# DRAINAGE LETTER

## 7280 N. NEVADA LANE

PCD File: PPR2411

Revised  
May 17, 2024

## DETENTION BASIN OUTLET STRUCTURE DESIGN

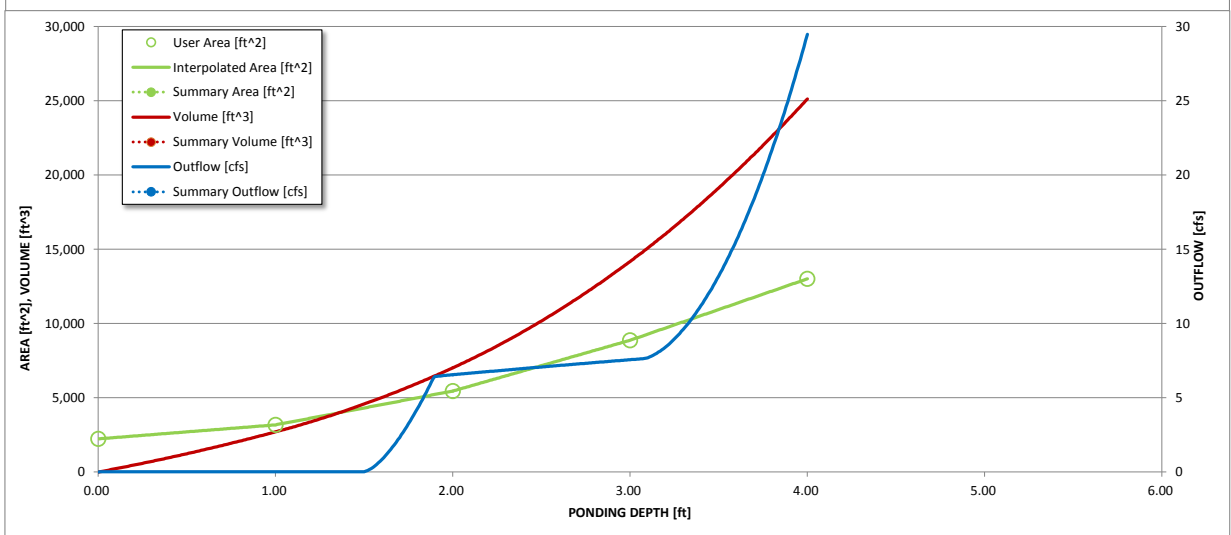
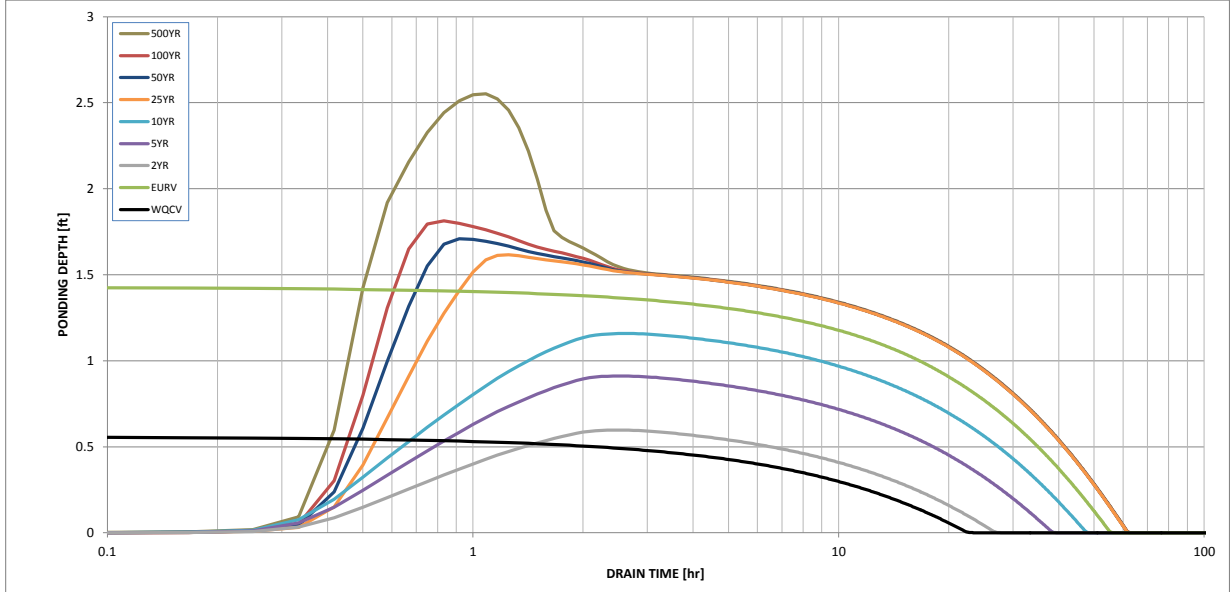
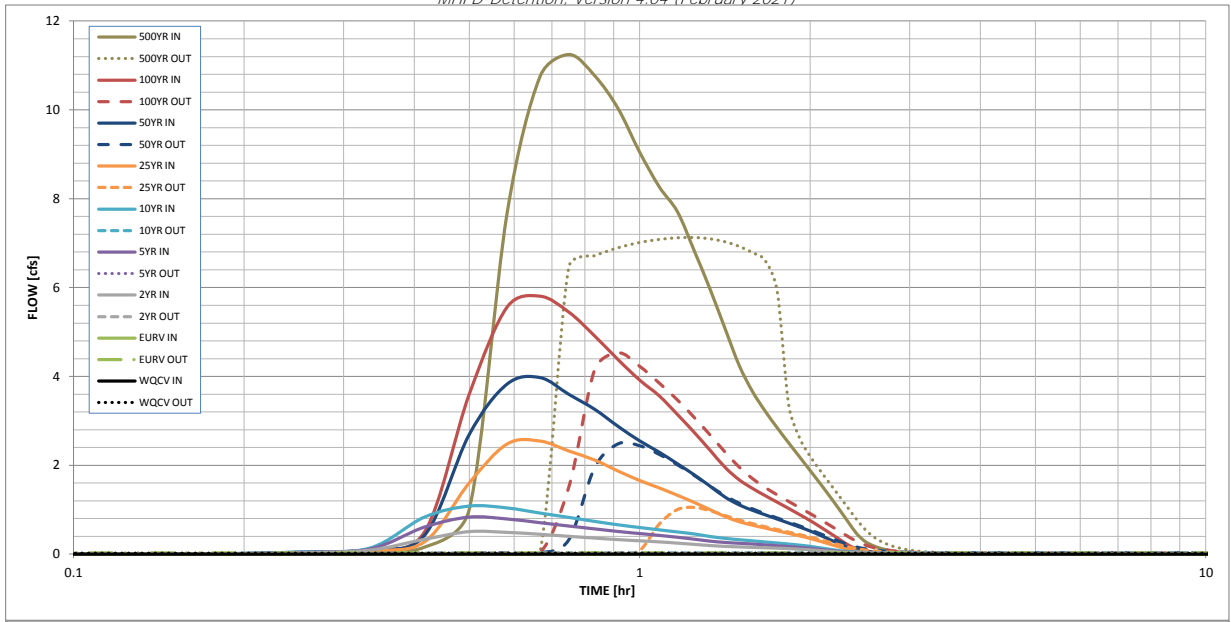
I cannot review these pond calcs without pond details. Please provide construction details for pond.

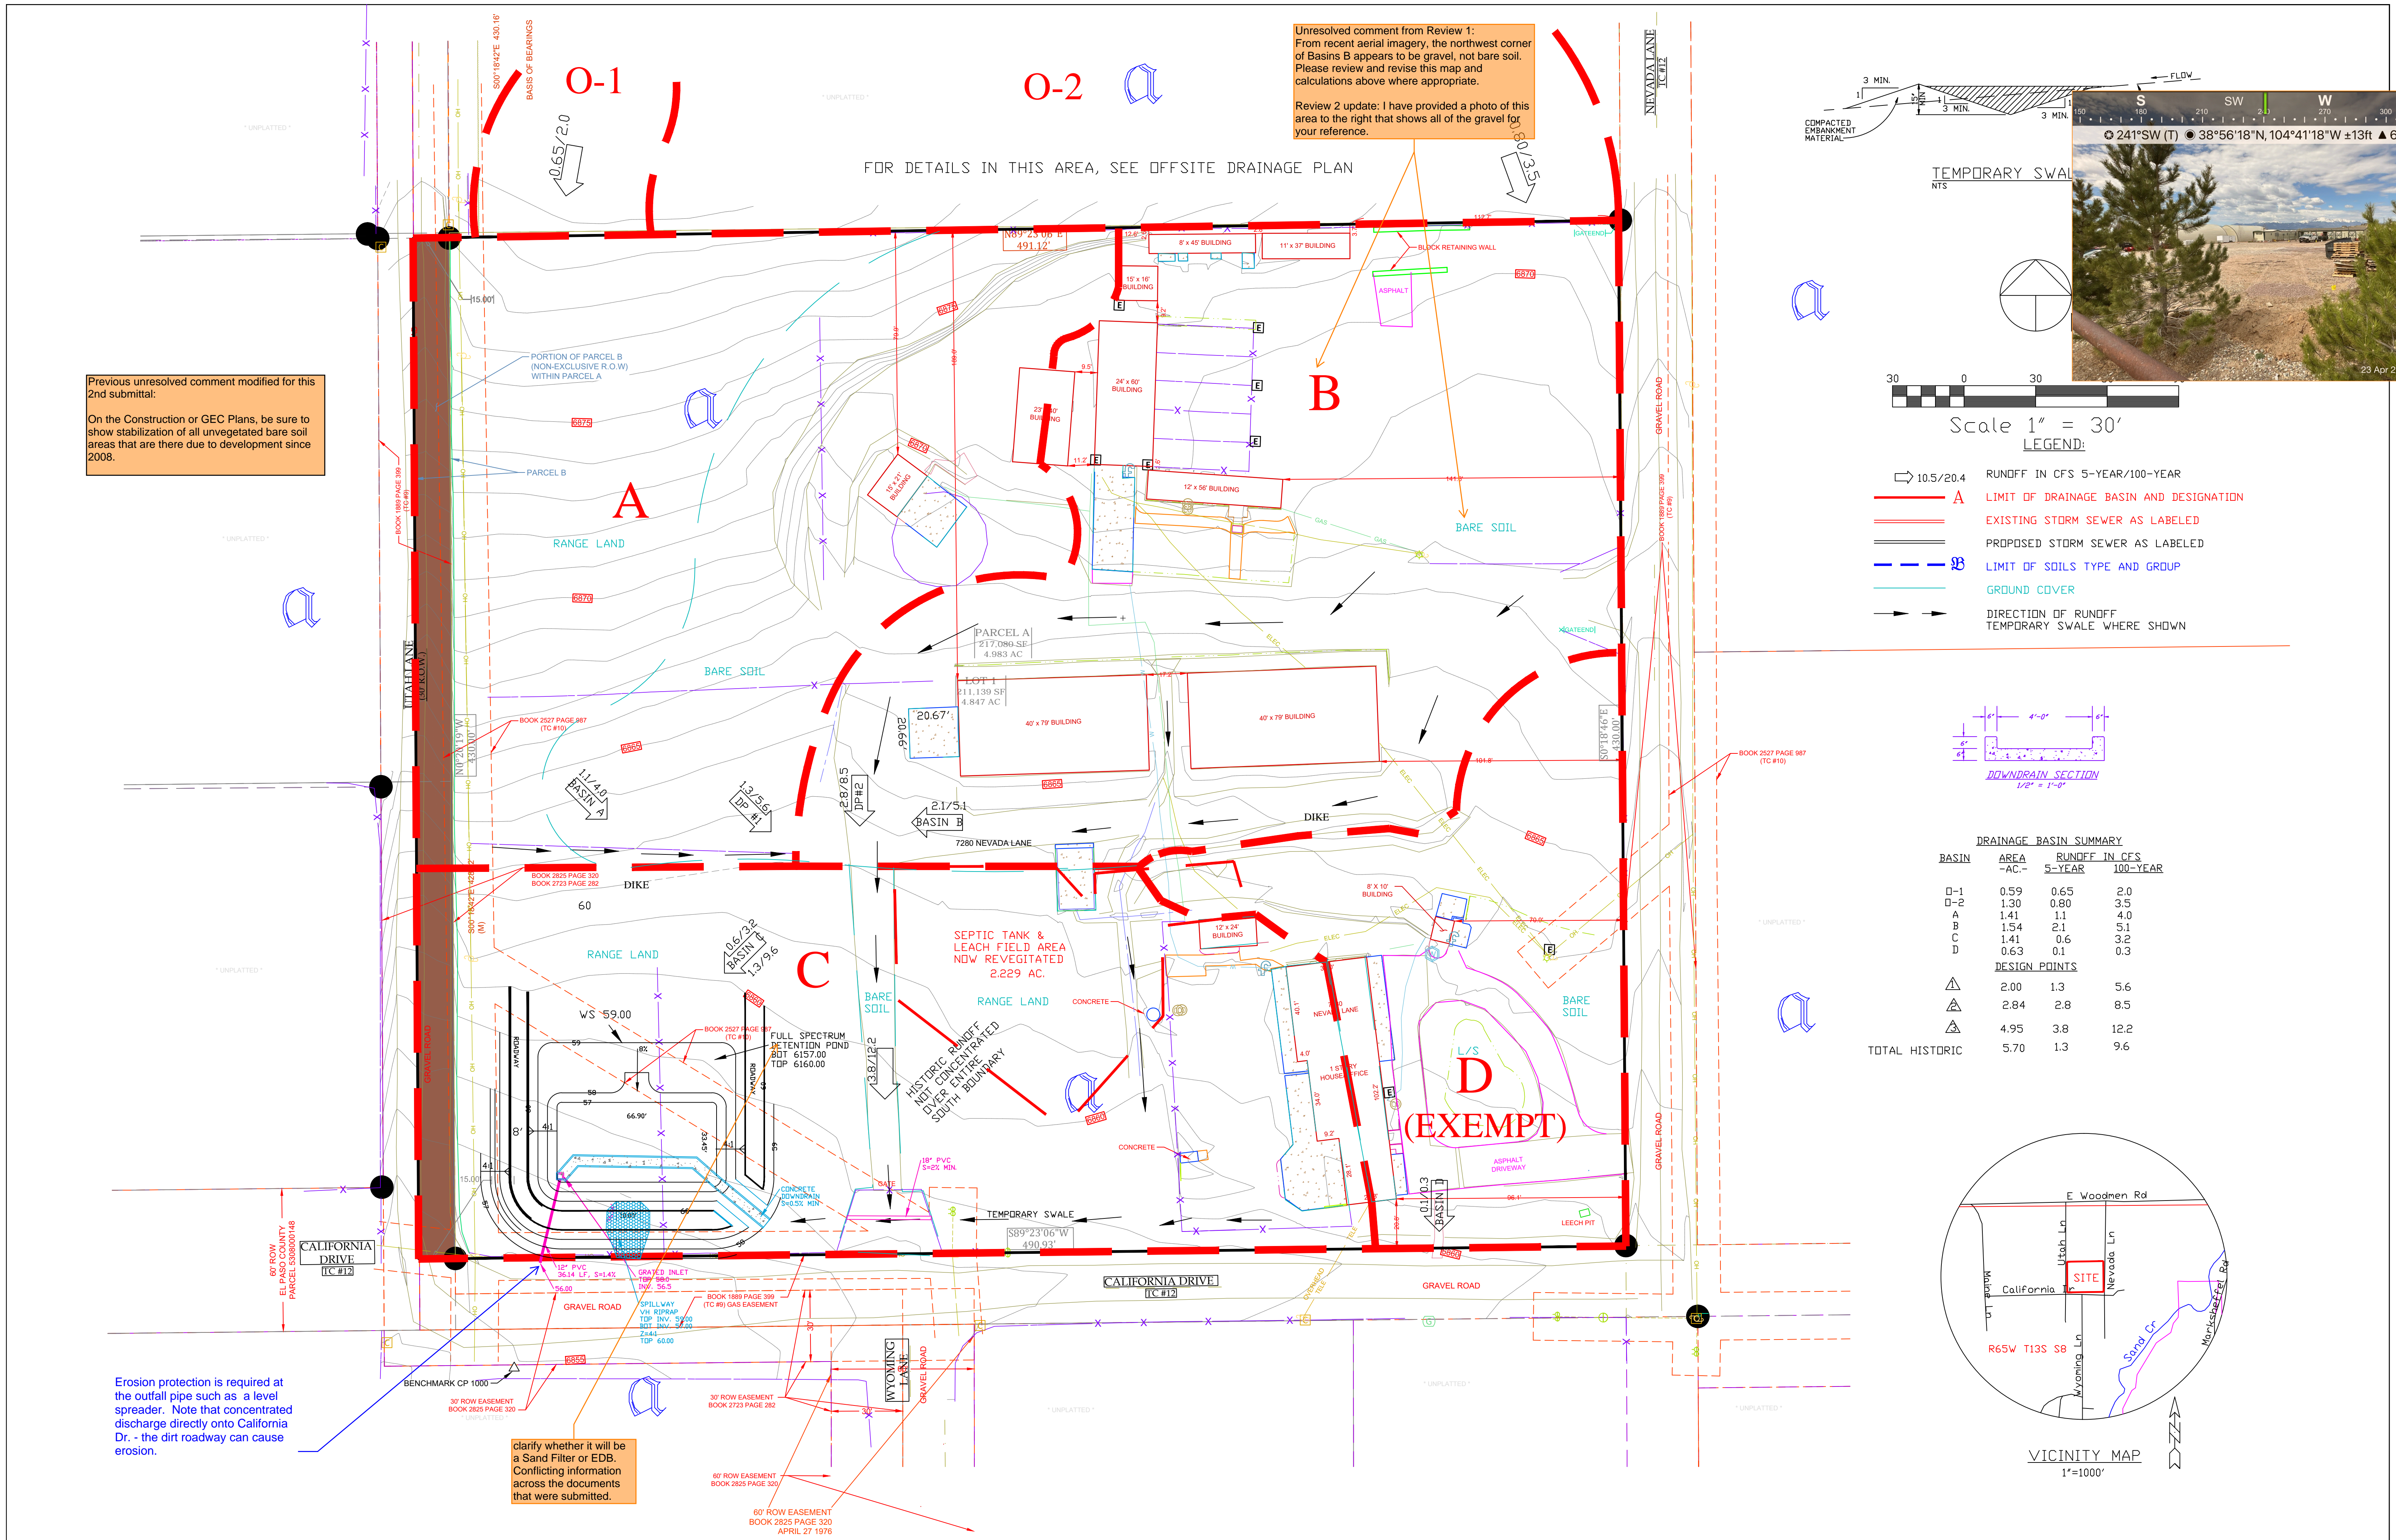
Unresolved comment from Review 1:  
 From recent aerial imagery, the northwest corner of Basins B appears to be gravel, not bare soil. Please review and revise this map and calculations above where appropriate.

Review 2 update: I have provided a photo of this area to the right that shows all of the gravel for your reference.

Previous unresolved comment modified for this 2nd submittal.  
 On the Construction or GEC Plans, be sure to show stabilization of all unvegetated bare soil areas that are there due to development since 2008.

clarify whether it will be a Sand Filter or EDB. Conflicting information across the documents that were submitted.

Erosion protection is required at the outfall pipe such as a level spreader. Note that concentrated discharge directly onto California Dr. - the dirt roadway can cause erosion.
